CERTIFICATE OF APPROPRIATENESS PLACARD

Construct rear patio; install side yard concrete paver walkway; construct 18" retaining wall; install new landscape plantings in rear yard

305 Kinsey St

COA-0071-2021

SI.1 | SITE PLAN

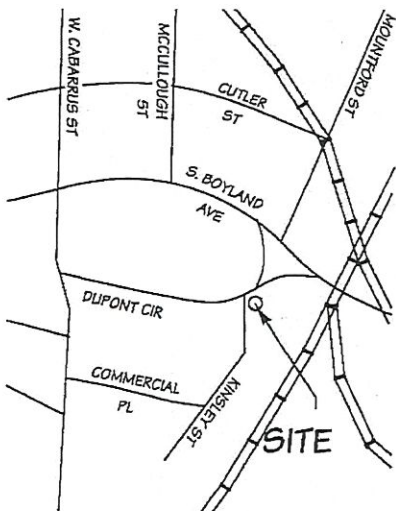
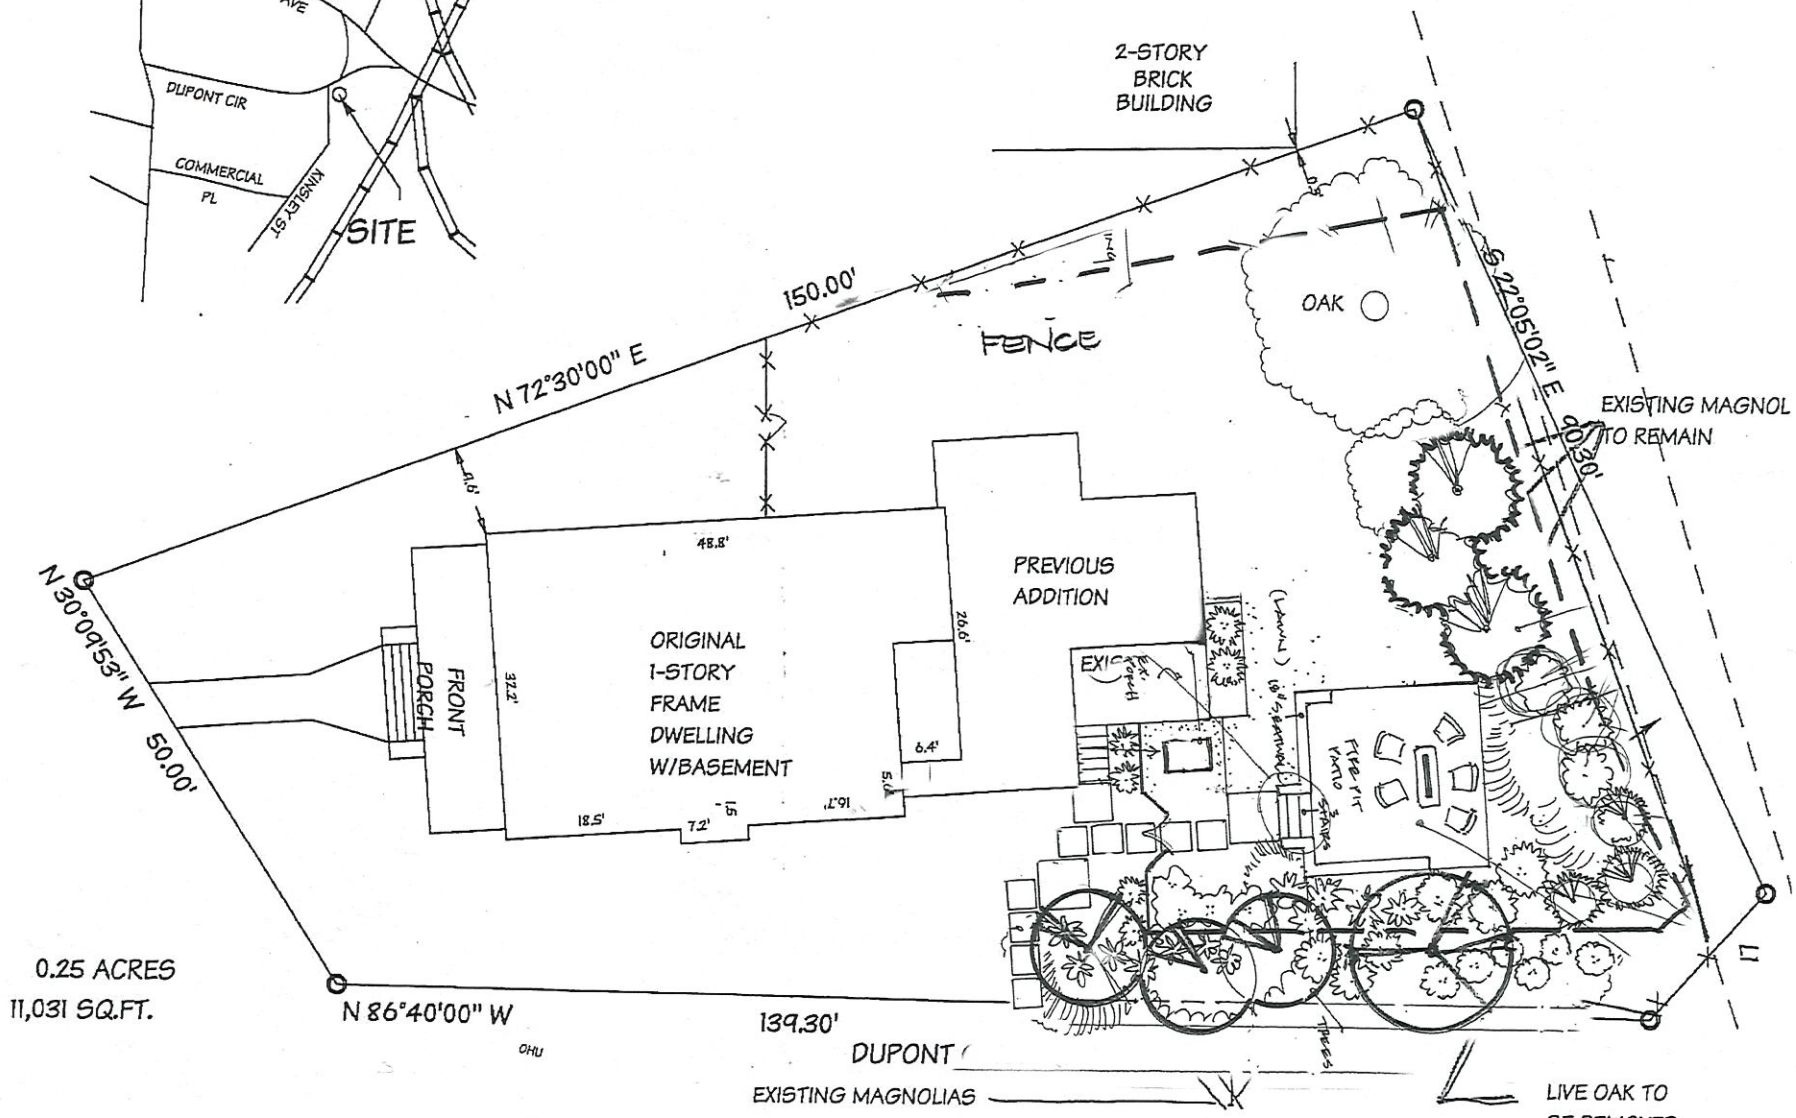
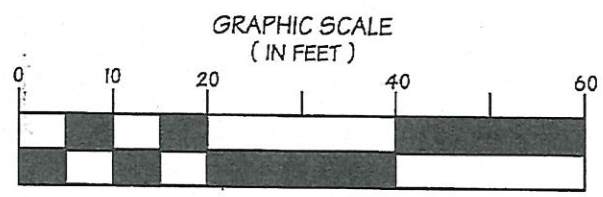
- The written description provided states that no trees are being removed. The site plan notes a live oak to be removed? Please clarify [No trees will be removed \(that was from a previous application site plan- the removal was approved a few years ago but I did not do it because of the cost and the shade is nice\).](#)

- Ensure proposed site plan doesn't show things that are not existing or proposed – for instance, there appear to be two fence lines shown? Please provide an accurate depiction of the proposed conditions. - [Corrected drawing below \(I had tried to update a site plan previously submitted\).](#)

LIVE OAK TO
BE REMOVED
(APPROXIMATE
LOCATION)

- Existing site plan with visual scale

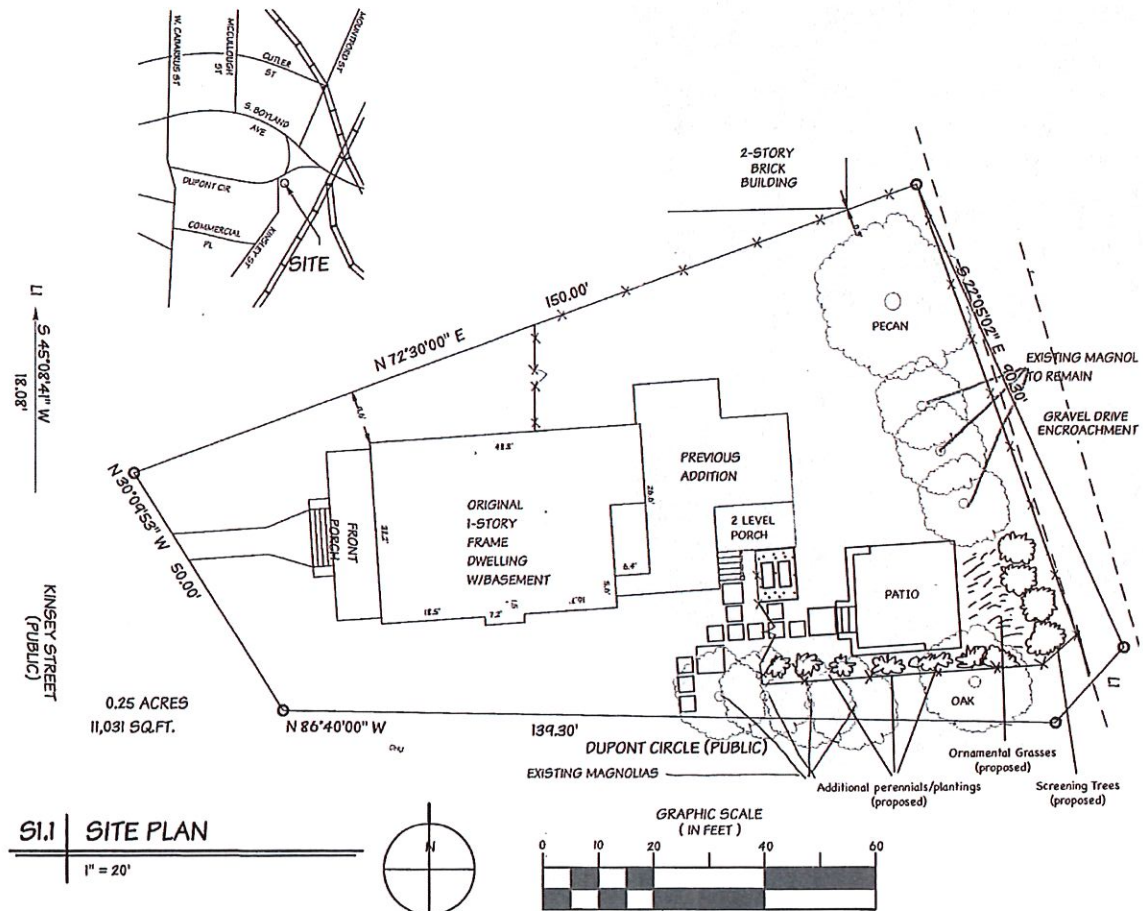
- Photos of the street-facing façades of the house from the street
- Photo of all areas of proposed work, including side yard and rear yard facing the house
- Existing site plan with visual scale
- Existing regulated tree information (at least 8" trunk diameter at 4'-6" above the ground), including the location, size, and critical root zones
- Expand written description to include summary of all proposed work shown on the proposed site plan
- The written description provided states that no trees are being removed. The site plan notes a live oak to be removed? Please clarify.
- Ensure proposed site plan doesn't show things that are not existing or proposed – for instance, there appear to be two fence lines shown? Please provide an accurate depiction of the proposed conditions.
